**Pacific Gas and
Electric Company**

PG&E Letter DCL-05-080

Docket No. 50-275, OL-DPR-80
Docket No. 50-323, OL-DPR-82
Diablo Canyon Units 1 and 2
License Amendment Request 05-02
Revision to Technical Specification 3.7.5, "Auxiliary Feedwater (AFW) System"

Figure 1
 Alternate Sources for AFW
 (circled valves are controlled by SR 3.7.5.6)

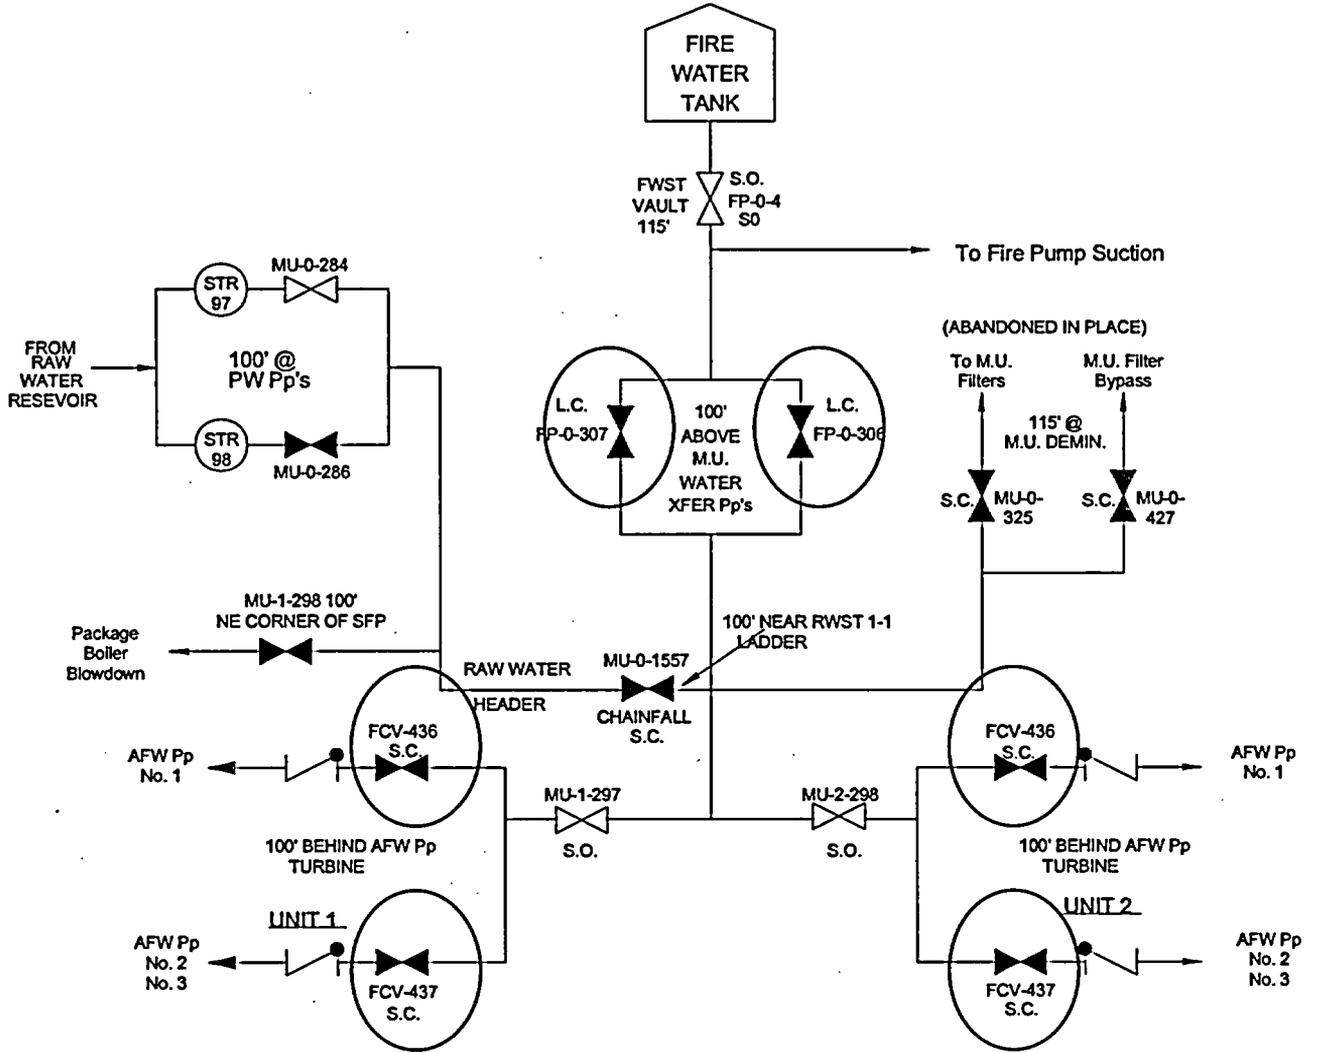
SR 3.7.5.6 frequency of 92 days is revised to 24 months.

The FWST supply valves controlled by SR 3.7.5.6 are:

FP-0-306
FP-0-307
FW-1-FCV-436
FW-1-FCV-437
FW-2-FCV-436
FW-2-FCV-437

These valves are shown circled on Figure 1 (next page).
